**STATE SIGNIFICANT DEVELOPMENT ASSESSMENT:  
Increase the Putrescible Waste Capacity  
Wetherill Park Waste Transfer Station  
SSD 7267**

Environmental Assessment Report  
Section 89H of the  
*Environmental Planning and Assessment Act 1979*

August 2017

Figure 5: Site Layout (as amended)

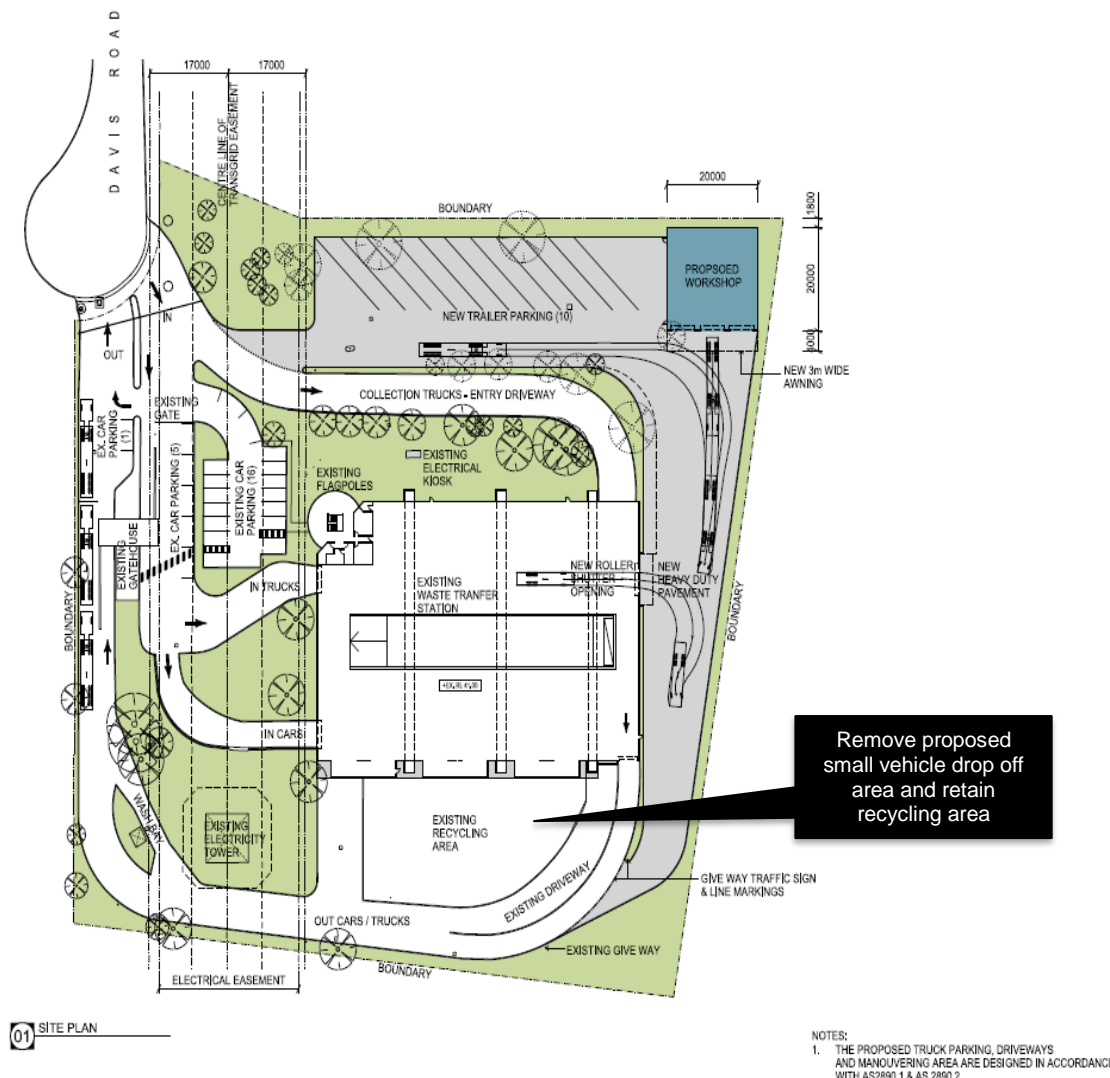
The application has been formally amended by the Applicant to reflect two changes to the development:

The original application envisaged complete site closure whilst the facility is upgraded to handle the additional processing capacity proposed. The Applicant now proposes to undertake these upgrade works in parallel with continued operations at existing processing capacity and without shutting down the facility.

Originally, a small vehicle drop off area and driveway was proposed within the existing recycling area. The Applicant has been advised by TransGrid that the development of the driveway cannot be supported as it is located within 5 m of a TransGrid stanchion and is therefore contrary to its technical guidelines which requires a 20 m setback to be provided (see **Sections 4.2** and **4.3**). As a result, the Applicant has excised this aspect of the development and plans to retain the small vehicle drop off area within the WTS building at this facility as well as the one present on its site at Eastern Creek.

Figure 17: Flood Depth Difference Proposed Less Base Case (1:100 AEP Peak Event)

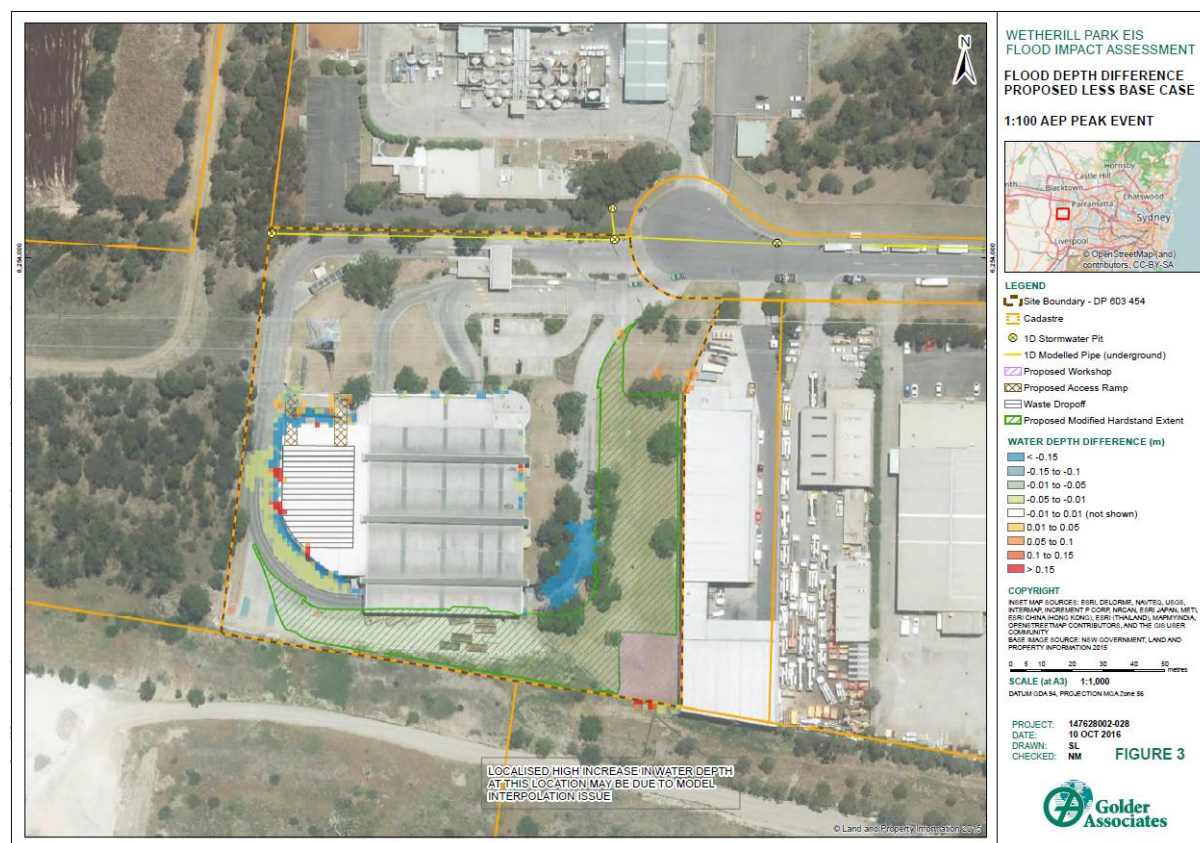
The Department has reviewed the FIA and provides the following summary (based on the 1:100 AEP flooding event):

- the natural flooding or drainage pattern of the floodplain would not be altered due to the relatively small area of physical development and resultant small net change in floodplain area;
- the highest predicted water depth for the base case and proposed case is greater than 1 m to the south of the existing building and at the eastern and western driveways;
- the proposed development would cause some relatively small increases and decreases in flood extent on certain short sections of concreted driveways (see **Figure 17**);
- in terms of scour, there would be a small change in the range of flood velocities across the site, and these would pose a low risk (+ 0.3 m/s); and
- the areas of the site categorised as medium and high hazard zones are restricted to the driveways in the southern portion of the site.

The FIA also found that the modelled 1:100 AEP flooding event is compliant with Council's DCP as the proposed development would not increase flood effects on any surrounding land. In particular, there would be no loss of flood storage and no change in flood levels or flood velocities on adjacent sites.

To supplement this, the Department also recommends a condition be imposed requiring the Applicant to prepare and implement a Flood Emergency Response Plan (FERP) for the site. This should include flood emergency responses (during both construction and operational phases), flood warning times and notification procedures, location and protocols to be followed at assembly points, evacuation routes and refuges and awareness training procedures for employees and contractors alike.

Both the Department and Council are satisfied with the findings of the FIA which indicates that there would be minimal change in flooding effects on site as a result of the proposed development and that there would be no change in flooding regimes on any adjoining land. It is also noted that flooding impacts would be less than predicted now the small vehicle drop off area has been excised from the proposal.
